Ducted Systems Technical Services Service Tips Letter

Letter: **ST-007-2019**

Subject: **Control Software Change – Variable Capacity Outdoor Control / Outdoor Display.**

Product: Residential Split System variable capacity heat pump and air conditioning models YZV, HC20, HL20, YXV, AC21, AL21

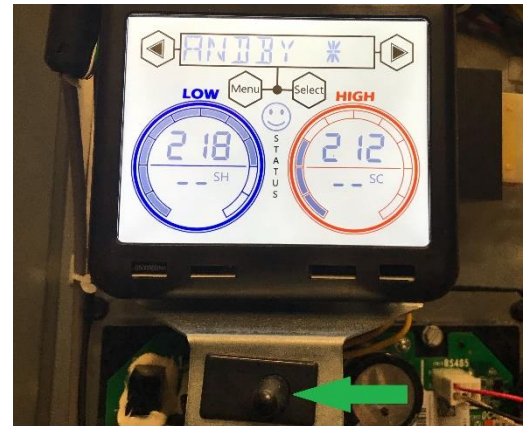
The model numbers listed above contain an outdoor control with an interactive touch screen display that is used for unit installation, control setup, equipment service, and diagnostics. The touch screen display contains a backlight feature and display is activated by a door switch located below the display as shown below.

The door switch utilized is a normally open switch. The switch is connected to the DOOR SWITCH terminal on the outdoor control using a wire harness that contains two yellow wires. When the door switch circuit is open, the backlight and display are activated. We have received complaints of damage to the door switch under normal use and service. The damage results in the door switch being stuck either open or closed. Since the variable capacity control activates the display when the door switch circuit is open, the end user can still use the control by unplugging the switch harness from the DOOR SWITCH terminal.

To improve product quality the door switch will be removed on new production units. Due to this, a new version of the software is required for the outdoor control. The variable capacity product is controlled by a touch screen HX™ thermostat. Software updates for this system are sent “OTA” (over the air.) On 05/10/2019 outdoor display software version, 1.08 will be sent out via a mass OTA update. Any system connected to Wi-Fi via the HX™ thermostat should receive this update. Once the update takes place, the outdoor unit door switch circuit will become inactive.

If a field installed unit is not connected to Wi-Fi it will not receive a software update. If the door switch fails and the control software is not at least version 1.08, the switch must be replaced with switch part number S1-02435738000.

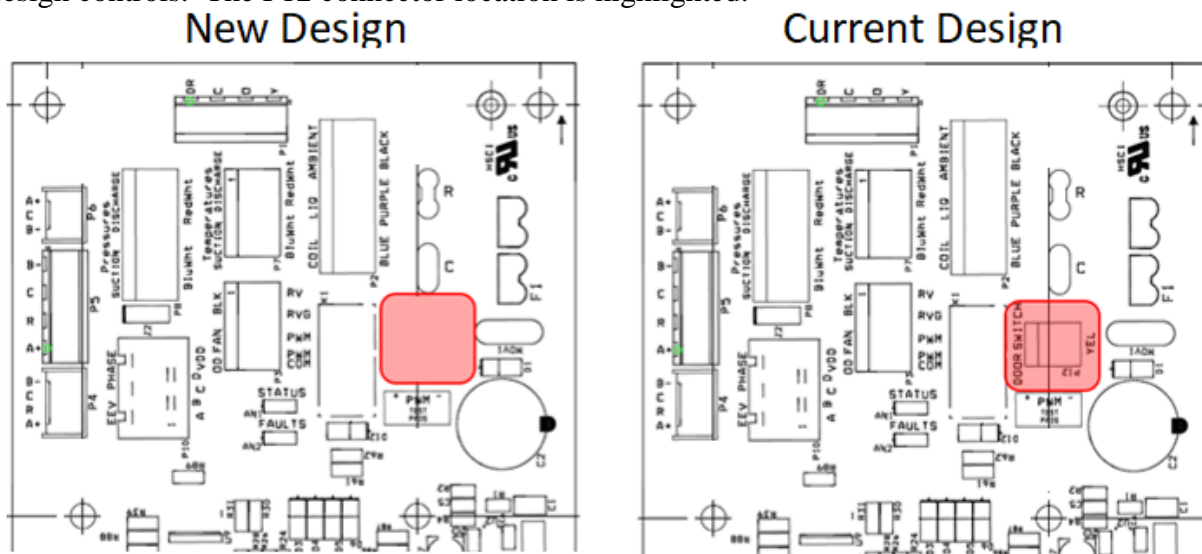
The variable capacity outdoor control door switch wiring connects to the P12 DOOR SWITCH terminal on the current outdoor control board. Moving forward, terminal P12 will be removed from this control, and controls will contain software version 1.08 or higher. The control part number will change to a kit number (S1-33103742000) that includes installation and operating instructions. Controls that do NOT contain the P12 door switch header will include a decal that includes operation instructions to activate the display. When factory inventory of outdoor controls containing the P12 header have been exhausted, production will shift to the new control and the units will NOT be built with an outdoor control door switch. See the example below of new and current design controls. The P12 connector location is highlighted.

If a replacement control is installed in a field installed unit and the control does not contain the P12 connector, the unit door switch and YELLOW door switch wire harness should be removed and discarded.

If a field installed outdoor unit receives outdoor control software update 1.08, the door switch will no longer be needed and should be removed during routine / yearly equipment maintenance. If the control software is at least version 1.08, the door switch will no longer function to activate or deactivate the display.
